City of West Linn
PRE-APPLICATION CONFERENCE MEETING
Notes
September 5, 2013

SUBJECT: Four lot subdivision at 1770 Ostman Road

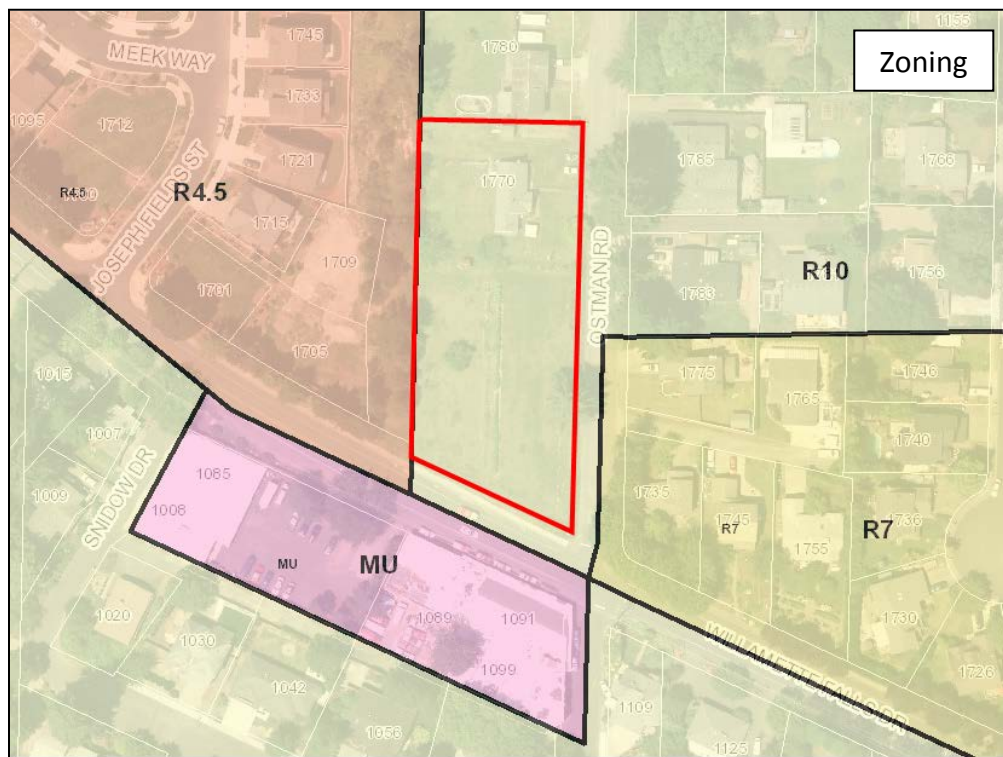
Subdivision and Lot Access: The applicant is proposing four lots that are each 10,000 square feet and dedicating 10' of ROW on both Ostman Road and Willamette Falls Drive. Staff notes that the preliminary site plan shows a 12' front yard setback rather than the 20' that is required. All of the lots would be accessed off of Ostman rather than Willamette Falls. **Staff would make this a condition in the subdivision approval.** This stretch of Ostman exceeds the block length in CDC 85.200(B)(2); however, the existing pattern of development in the area precludes any increased street connectivity.

CDC 48.060(C)(4) states that there shall be no curb cuts on a collector (Ostman) within 100 feet of intersecting an arterial (Willamette Falls Dr.). In addition, CDC 48.060(D)(2) states that there shall be a minimum distance of 75 feet between any two adjacent curb cuts on the same side of a collector. All curb cuts shown on plans must comply with these requirements. One option to address this is applying for a Class II variance for CDC 48.060(C)(4) and having lots 1 and 2 share a driveway. Lots 3 and 4 could share another driveway and the spacing would meet CDC 48.060(D)(2).

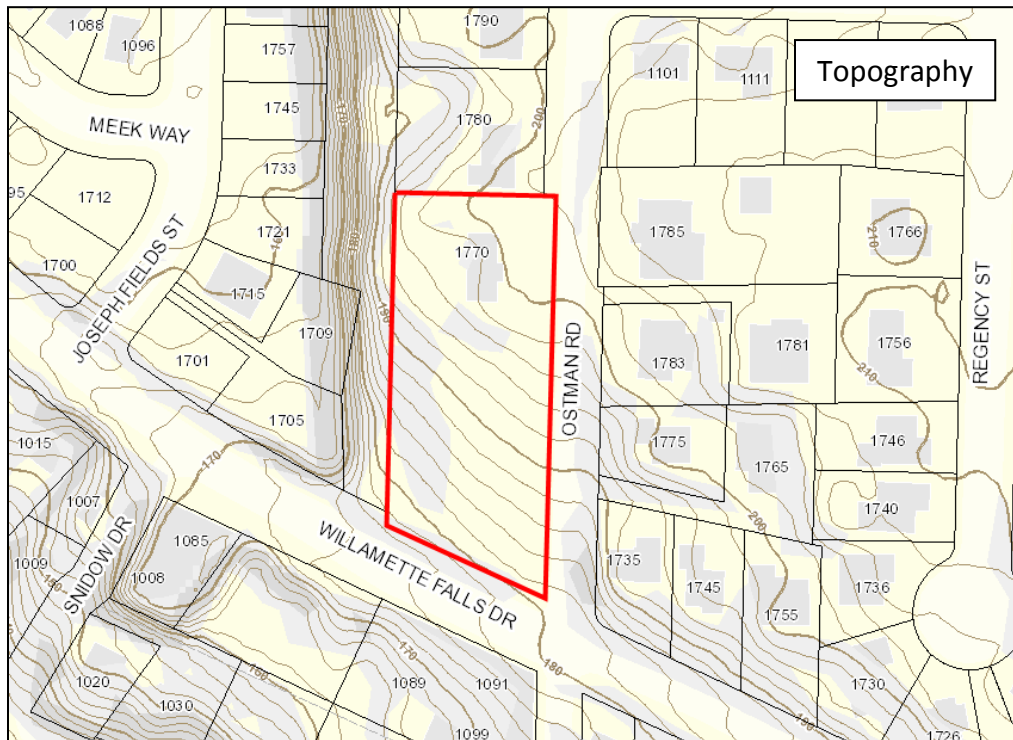
Topography: The site slopes downhill an average of 8% from about 202 feet elevation at the northeast corner to about 177 feet in the southwest corner. A portion of the site along the western perimeter has slopes between 10-25% (light grey). This falls much more steeply on the

adjacent tract that is part of the Arbor Cove subdivision (25% and higher is shown in dark grey). There are no natural hazards or environmental constraints.
